## Kurri Kurri Lateral Pipeline Project update

## Attachment 1 – Design refinements

## Attachment 2. Comparison of EIS design and amended design.

### JGN Offtake Facility

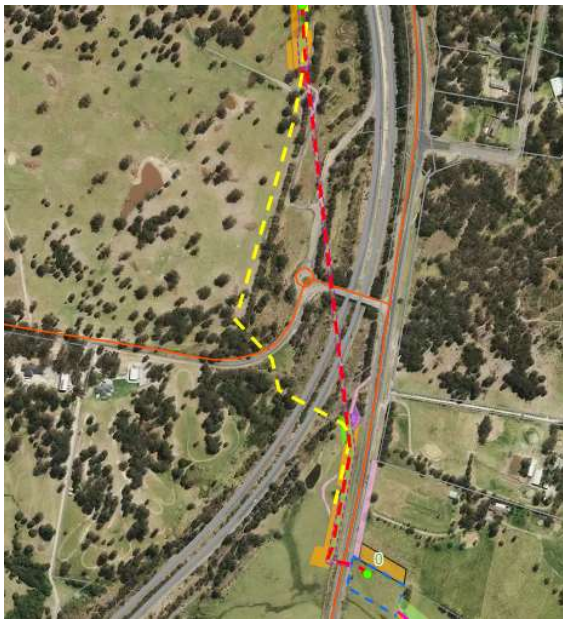
The KKLP EIS presented the JGN offtake facility on the western side of Lenaghans Drive (Lot 51 DP1158920) based on favourable consultation with the landholder. Ongoing negotiations with the landholder have, however, been unable to reach an agreement for locating the offtake facility on this property. As such, discussions with adjacent landholders have been undertaken with a view to locating the offtake facility on a nearby landholding.

APA have subsequently reached in-principle agreement with the landholder on the eastern side of Lenaghans Drive (Lot 453 DP 807778) for locating the JGN offtake facility with the proposed location shown below. This landholding hosts the Sydney to Newcastle Pipeline and remains proposed for the short section of interconnecting pipeline between the SNP and JGN delivery facility.

The proposed location is approximately 70m from the EIS location at its' closest point. Access to the proposed location will be either through the affected landholding or the landholding to the north. Positive discussions have been held with the landholder to the north (Lot 4512 DP573791) and it is likely that the access track will be constructed on this lot.

The JGN offtake facility and JGN delivery facility (to be owned and operated by Jemena) will continue to be co-located. The area encompassing both facilities is proposed to be freehold land to be owned by APA following planning and pipeline licensing approval. The JGN delivery facility (to be owned and operated by Jemena) will be within an easement overlapping the APA owned land.

To achieve efficiencies during construction, APA now proposes to complete civil earthworks and foundations for the access road,

construction pad and laydown areas for both facilities, likely using a single construction contractor. As such the construction footprint of both facilities will be assessed in the Amendment Report. Jemena will retain responsibility for the subsequent construction, commissioning and operation of the JGN delivery facility.

### Buchanan Road - East

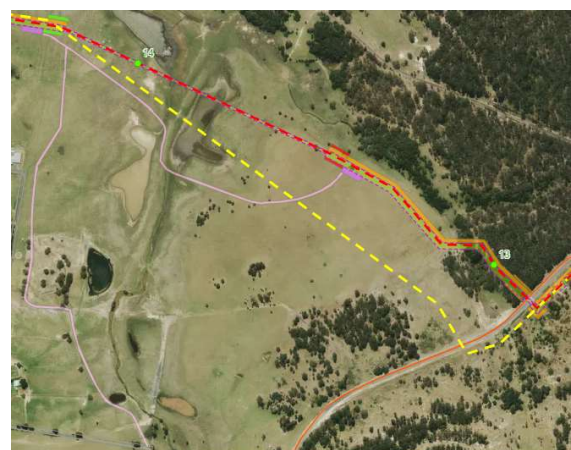
APA has held ongoing discussions with the landholder (Ashtonfields) regarding the positioning of the alignment between approximately KP11.0 and Buchanan Road. The key constraints for the transmission pipeline alignment in this area are existing residential areas immediately north of Lot 1 DP 1045723, old underground mine workings, remnant vegetation, and potential residential development following completion of mining operations.

The preference of the landholder is for the alignment to follow Hunter Water trunk mains to the north-west, then the northern and western boundaries of Lot 1 DP 1045723. No new landholders are directly affected by this option, as shown in the figure below.
